Amendments to the drawings

Remarks:

Fig. 1

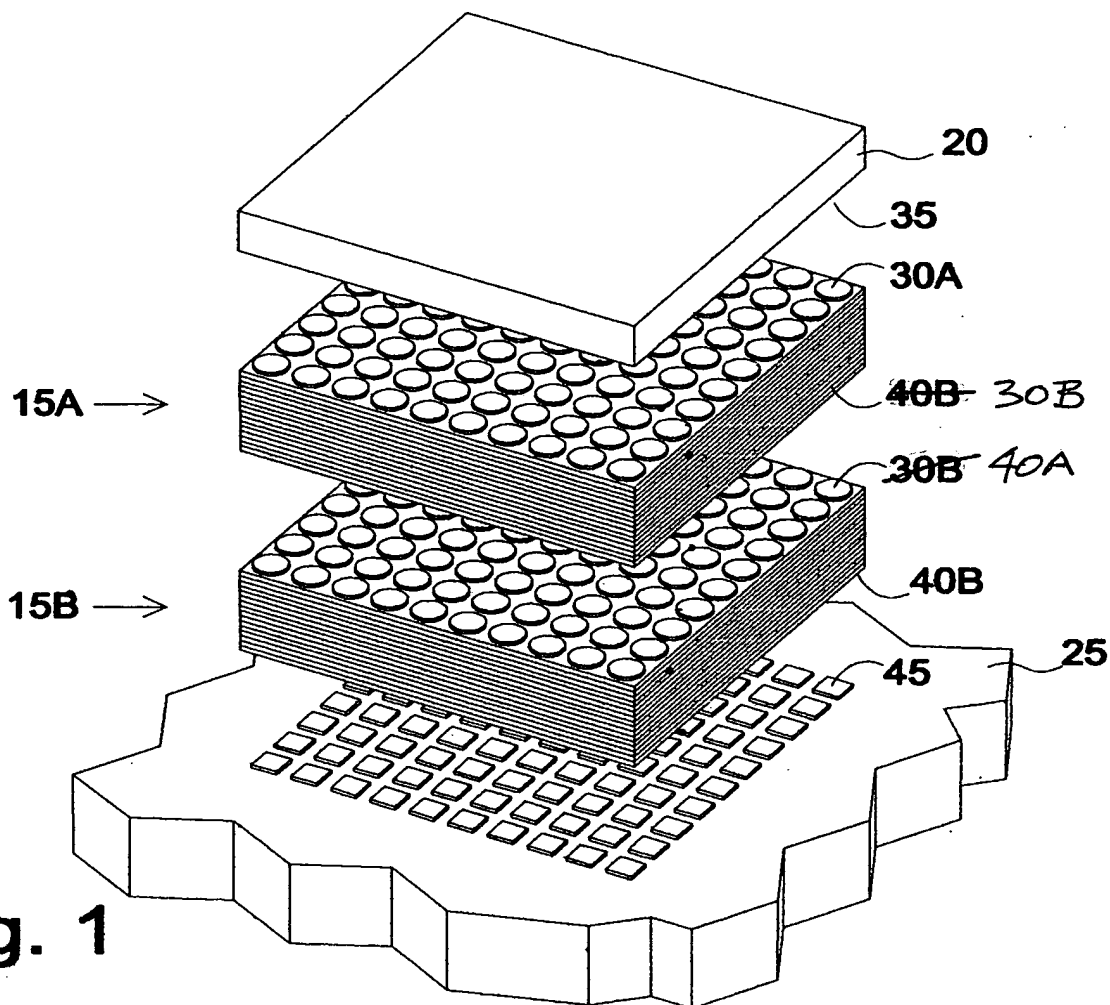
In Fig. 1, reference designator 40B on the upper interface connector assembly 15A is incorrect and is hereby changed to 30B and reference designator 30B on the lower interface connector assembly 15B is incorrect and is hereby changed to 40A.

Fig. 5A

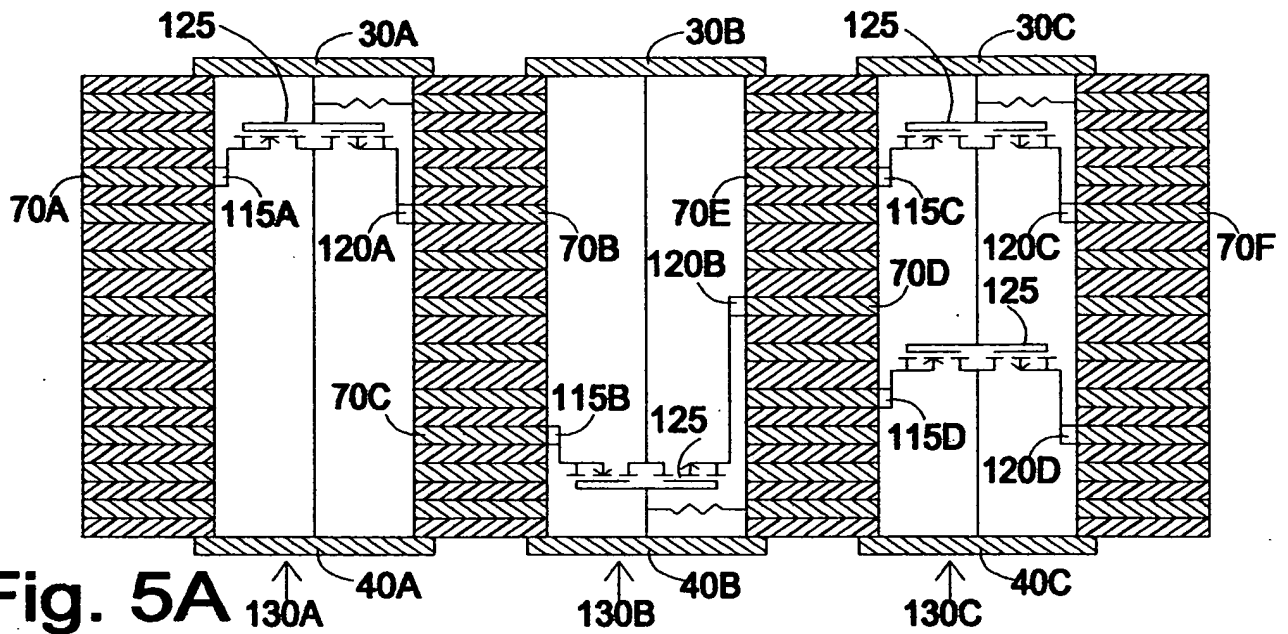
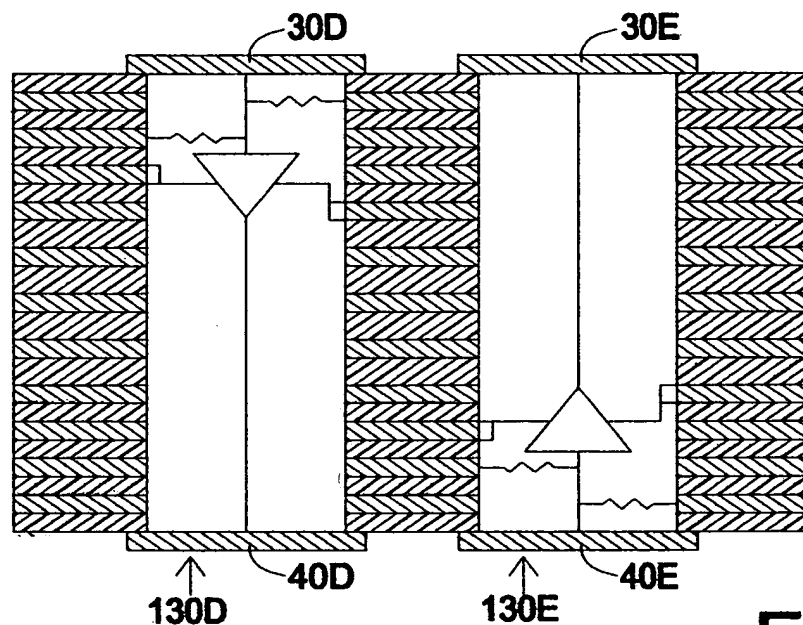
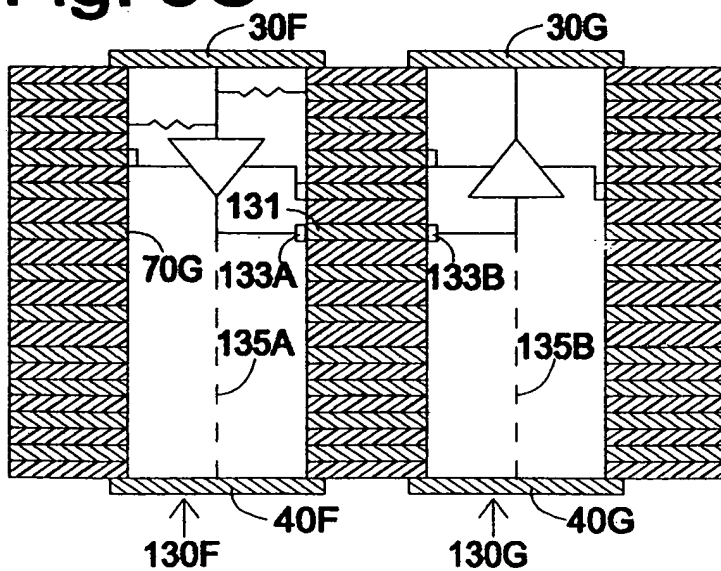
In Figs. 5A-5D the hatching for insulating material has been changed to better distinguish from hatching for metal material.
